RS-10-094

Braidwood Station, Units 1 and 2
Facility Operating License Nos. NPF-72 and NPF-77
NRC Docket Nos. STN 50-456 and STN 50-457

Byron Station, Units 1 and 2
Facility Operating License Nos. NPF-37 and NPF-66
NRC Docket Nos. STN 50-454 and STN 50-455

Subject: Additional Information Supporting License Amendment Request to Change Fire Protection Program Requirements for Upper Cable Spreading Rooms

Figure: Typical UCSR Cable Riser Floor Seal

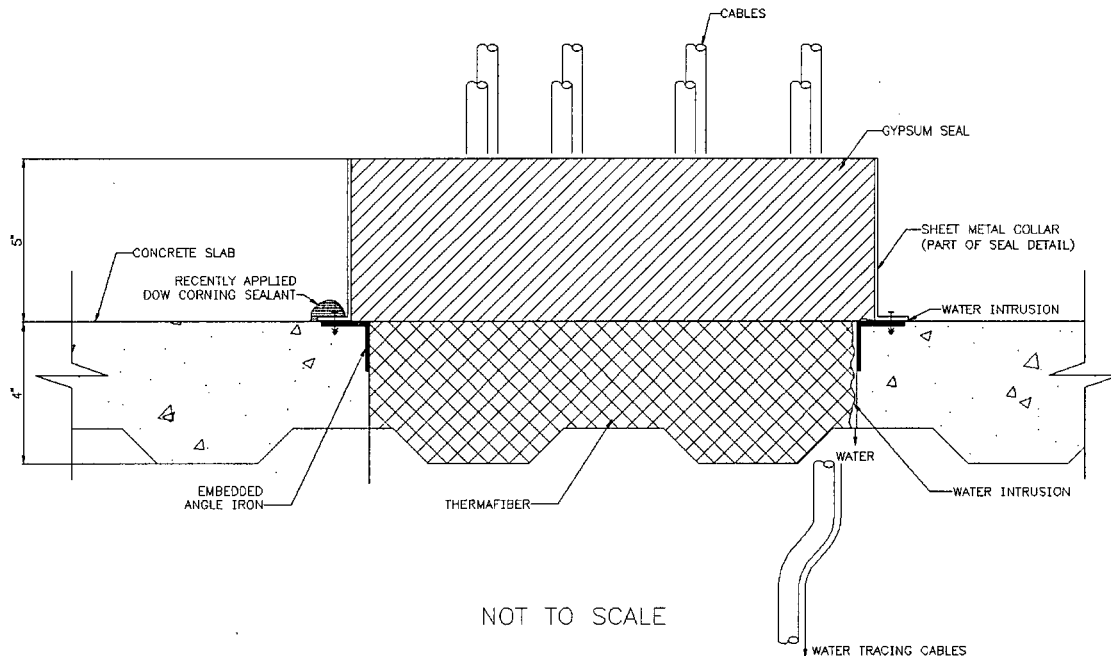
Provide an analysis of the impact of using firefighting water in the UCSR in light of the design of the UCSR floor fire seals, or justify why such an analysis is not necessary.

The configuration of a typical cable riser floor fire seal in the UCSRs is shown in the figure below. The configuration of the subject fire seals consists of a 5" high, 18 gauge, sheet metal collar anchored to the floor surrounding the floor opening. The collars are approximately 1" to 2" longer and wider than the opening, creating a horizontal overlap between the gypsum and the concrete. During installation, damming material was installed inside the opening below the collar, and the gypsum material was then poured into the collar, starting flush with the surface of the concrete floor, overlapping the concrete horizontally approximately 1" to 2" around the perimeter of the seal, and rising up within the collar to form a seal around the penetrating items. The installed gypsum overlaps the opening on each side, but does not extend below the top surface of the floor into the opening.

The seals have been qualified as 3-hour fire seals per IEEE 634, "Standard Cable-Penetration Fire Stop Qualification Test," and ASTM E119, "Standard Test Methods for Fire Tests of Building Construction and Materials." The fire seal testing included multiple hose stream tests per ASTM E119, which verified that a hose stream would not dislodge a fire seal and would not project water beyond the unexposed surface of the fire seal. Note that these fire seals are also rated as ventilation seals; however, these seals do not have a flood seal rating.

Flood-rated seals were not installed in this application since the UCSR elevation 463'-5" floor is not designed as a flood rated barrier. This is due to the only source of water being the Fire Protection piping to the installed hose stations. The probability of failure of this system is considered low since it is a low pressure system not subject to transients. Flood calculations performed for each of the UCSR compartments show that the floor drains are sized for expected releases or in-flow of water to the area without significant buildup of standing water. The calculated height (i.e., less than two inches) is less than the height of the metal collars surrounding the penetrations; therefore, leakage is not expected.

Since the recent events at Byron Station, both stations have taken actions in accordance with the Corrective Action Program to improve the water resistance of the UCSR floor penetrations. Byron Station recently completed the process of applying sealant at the floor to collar interfaces, bolt holes, and vertical seams. During this process, additional potential sources of in-leakage (i.e., conduit sleeves, ventilation ducts, and support base plates with through-bolted floor attachments) were also sealed.

A potential leak path for the standing water would be through the interface between the collars and the floor. However, actions are being taken to caulk this interface to address the concern about water leakage through the collar/floor interface. Since water levels above the top of the curbed openings or fire barrier collars are not expected, the caulked fire/ventilation seal configuration will be sufficient to prevent potential water intrusion/leakage events during normal plant operation (i.e., postulated line breaks or hose station leakage) and during fire fighting conditions where water spray may be used.

Given the actions to verify the proper operation of the floor drain systems and to caulk leakage points at the floor-seal interfaces, as well as ASTM E119 qualification testing that demonstrates the installed seals will not project hose stream water to the cold side of the seal, potential mechanisms for leakage of water through the seals have been addressed. Therefore, an analysis of the impact of using firefighting water in the UCSR in light of the design of the UCSR floor fire seals is not necessary.
